SERVICE BULLETIN
SUMMARY

**TITLE: AIR CONDITIONING - AVIONICS EQUIPMENT VENTILATION -
OPTIMIZE VENTILATION OF T3CAS INSTALLED IN 82VU**

MODIFICATION CLASSIFICATION					
MAJOR	None				
MINOR	152526K15298

MODIFICATION No.: 152526K15298

Figure A-GBAAA - Sheet 01
Modify the Cover of ventilation holes

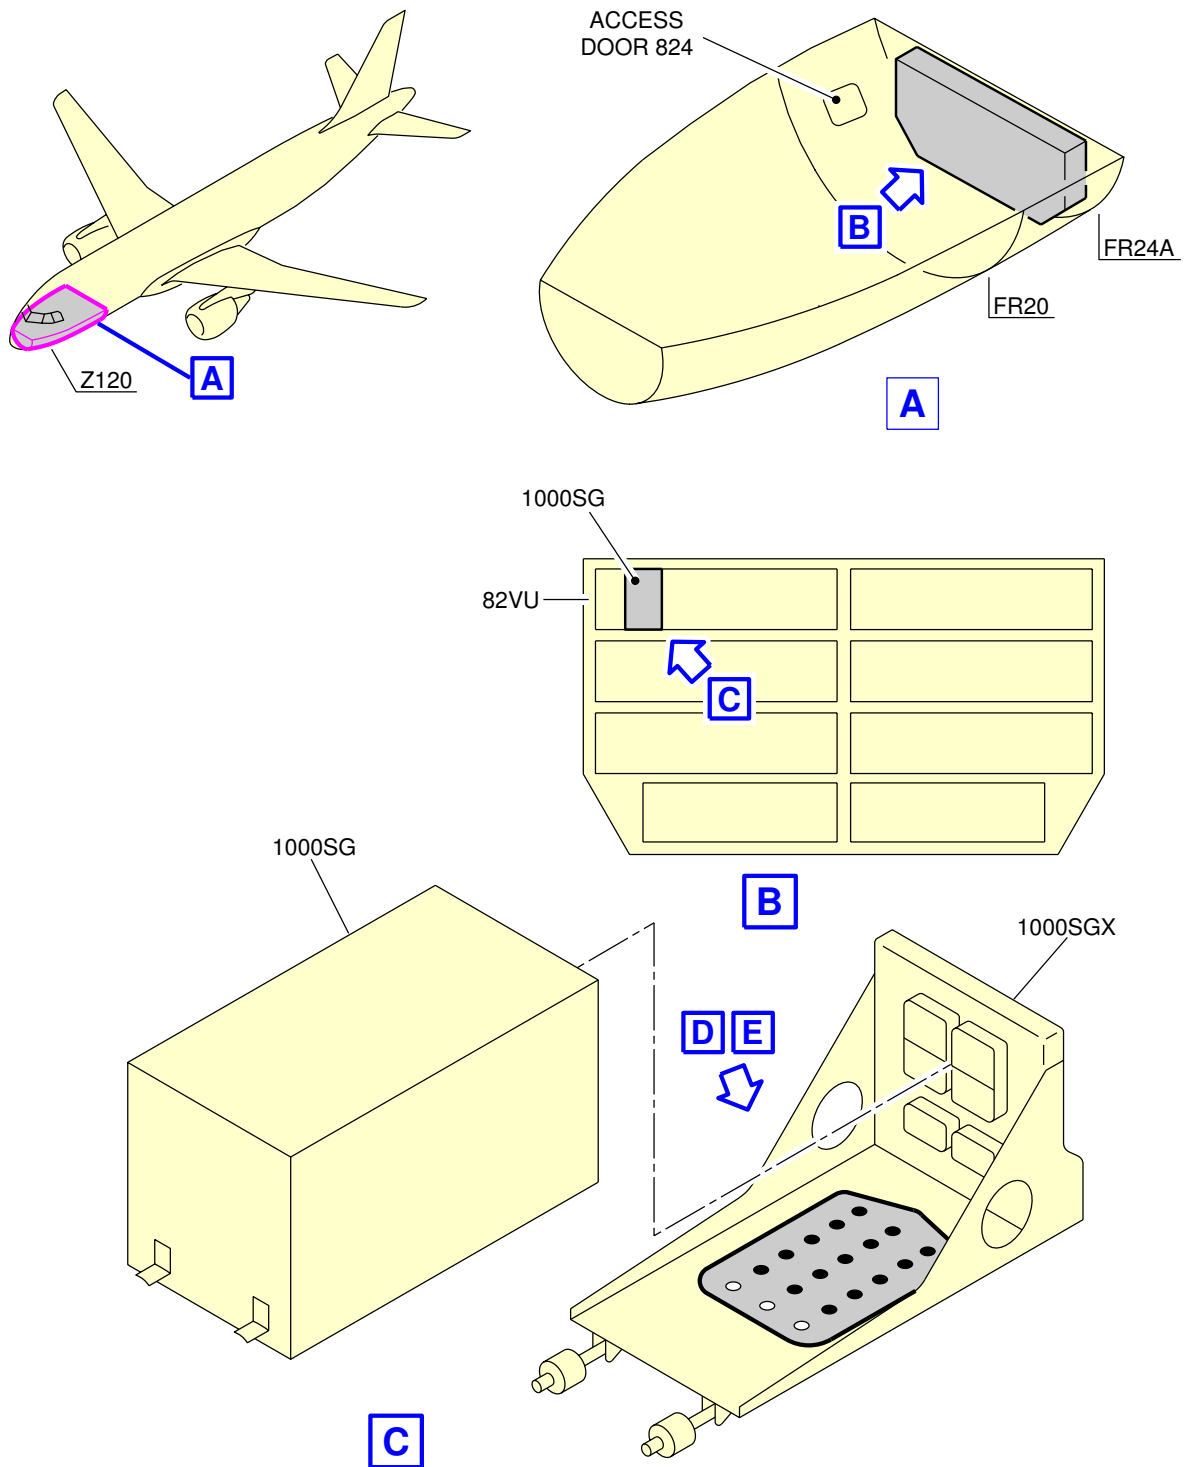
Investigations have shown, that the T3CAS computer is not sufficiently cooled by air. The reason for the insufficient air cooling is the non optimized position of the open ventilation holes.

To improve the airflow, it is necessary to adjust the ventilation hole plugs on the rack into an optimized position.

- (a) To close the ventilation holes at the avionic rack 1000SGX, install as shown on [Fig. A-GBAAA Sheet 01](#), View C and [Fig. A-GBAAA Sheet 02](#), E 'AFTER':
- 3 Cover NSA939511-03 Item 1
- (b) To open new ventilation holes at the avionic rack 1000SGX, remove as shown on [Fig. A-GBAAA Sheet 01](#), View C and [Fig. A-GBAAA Sheet 02](#), View E 'AFTER':
- 3 Cover NSA939511-03 Item (1) Discard
